Re: Pflugerville Surface Water Treatment Plant Standby Generator
Change Order #02 Recommendation

DATE: 11/18/2022
TO: City of Pflugerville
ATTN: Brandon Pritchett
EMAIL: brandonp@pflugervilletx.gov
SUBJECT PROJECT: City of Pflugerville SWTP Standby Generator - Change Order #2

Project Name: City of Pflugerville Surface Water Treatment Plant Standby Generator	Contractor: McDonald Electric
RFI Number: 15	Engineering Firm: Gupta
Prepared By: Brad Hibbetts	Attn: Mazhar Hajizadeh
Date Response Needed: 05/13/2022	Plan Sheet: 00E05

**TRANSFORMER PAD
THREE PHASE
1500 - 2500 KVA RADIAL**

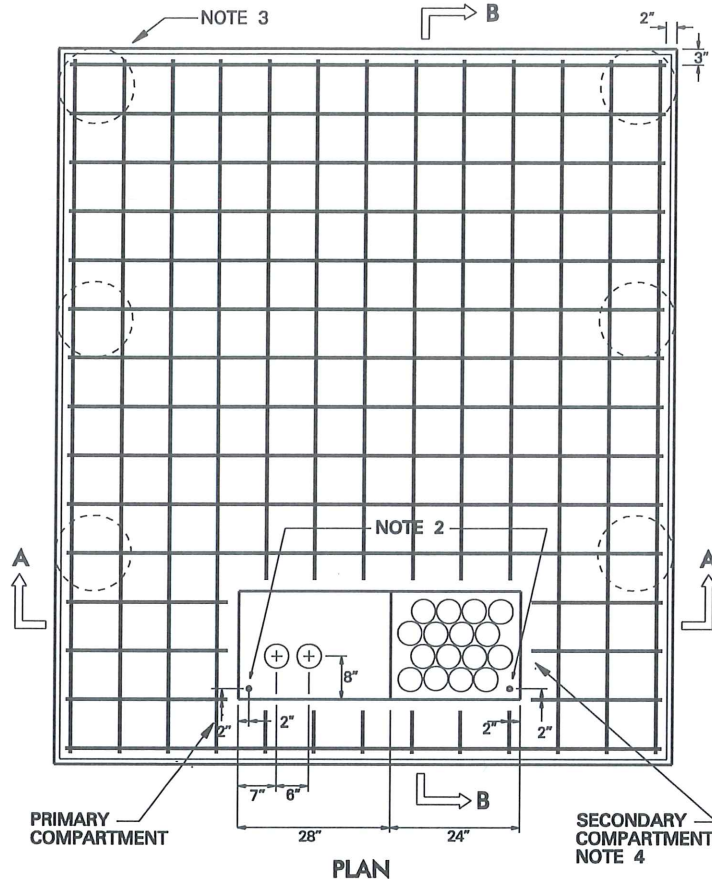
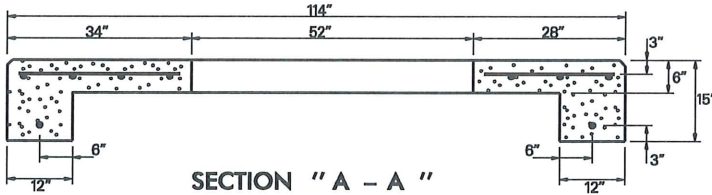
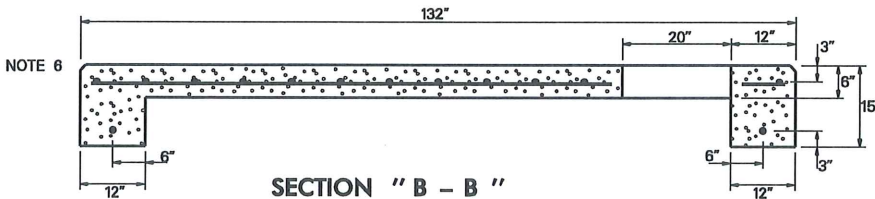
4	Load bank connection box pad 4' x 4'.	\$ 18,662.26
RFI #15		
2500	In lieu of transformer pad detail E23/00E05, install an 8'x9' mat foundation with dimensions and reinforcing per the Oncor detail, sheet 27 without piers. Over-excavate and remove 6' depth of existing expansive fat clay soil. Extend the lateral limits of the excavation 2' beyond the perimeter of the foundation. Backfill and compact per RFI #15 response. Provide a 12" thick clay cap around the perimeter of the foundation, compacted per RFI #15 response.	\$ 15,967.15
1000	In lieu of transformer pad detail E23/00E05, install a 6'x8.5' mat foundation with dimensions and reinforcing per the Oncor detail, sheet 27 without piers. Over-excavate and remove 6' depth of existing expansive fat clay soil. Extend the lateral limits of the excavation 2' beyond the perimeter of the foundation. Backfill and compact per RFI #15 response. Provide a 12" thick clay cap around the perimeter of the foundation compacted per RFI #15 response.	\$ 12,410.57

Details: The pad detail on sheet 00E05 note 2 refers to structural drawings for a transformer pad detail. We do not see a transformer pad detail in the structural drawings. We have included a ~24" slab on grade pad as depicted in the electrical detail with reinforcing similar to the generator pad shown on 15S01. Please advise if this is sufficient or if there are additional requirements.

~~USE A MAT FOUNDATION WITH 24" THICKNESS. REINFORCE WITH #6 TOP BARS WITH STANDARD HOOKS @ 12"C/C, EW, AND #6 BOTTOM BARS @ 12"C/C.~~

OVER-EXCAVATE AND REMOVE A MINIMUM 6'-0" DEPTH OF EXISTING EXPANSIVE FAT CLAY SOIL. EXTEND THE LATERAL LIMITS OF THE EXCAVATION 2'-0" BEYOND THE PERIMETER OF THE FOUNDATION. BACKFILL WITH CRUSHED LIMESTONE BASE MATERIAL (TXDOT STD SPEC ITEM 247, GRADE 1-2, TYPE A) OR NON-EXPANSIVE SELECT FILL (SOILS CLASSIFIED AS SP, SM, SC, CL, OR DUAL CLASSIFICATIONS THEREOF, LIQUID LIMIT NOT GREATER THAN 35, PLASTICITY INDEX BETWEEN 7 AND 15, FREE OF ORGANIC MATERIALS). PLACE BACKFILL IN 8" LOOSE LIFTS, COMPACT TO A MINIMUM OF 95% OF MAXIMUM DRY DENSITY (ASTM D698), AT A MOISTURE CONTENT WITHIN -1% TO +2% OF THE OPTIMUM MOISTURE. PROVIDE AN 12" THICK COMPACTED CLAY CAP AROUND THE PERIMETER OF THE FOUNDATION OVER THE BACKFILL. EXTEND THE CLAY CAP 2'-0" HORIZONTALLY BEYOND THE LIMITS OF THE BACKFILL. THE CLAY CAP SHALL BE CLAYS AND SANDY CLAYS, LIQUID LIMIT NOT LESS THAN 30, PLASTICITY INDEX NOT LESS THAN 15, MORE THAN 50% PASSING THE NO. 200 SIEVE, FREE OF ORGANIC MATERIALS. PLACE CLAY CAP IN 8" LOOSE LIFTS, COMPACT TO A MINIMUM OF 95% OF THE MAXIMUM DRY DENSITY (ASTM D698), AT A MOISTURE CONTENT WITHIN +0% TO +5% OF THE OPTIMUM MOISTURE.
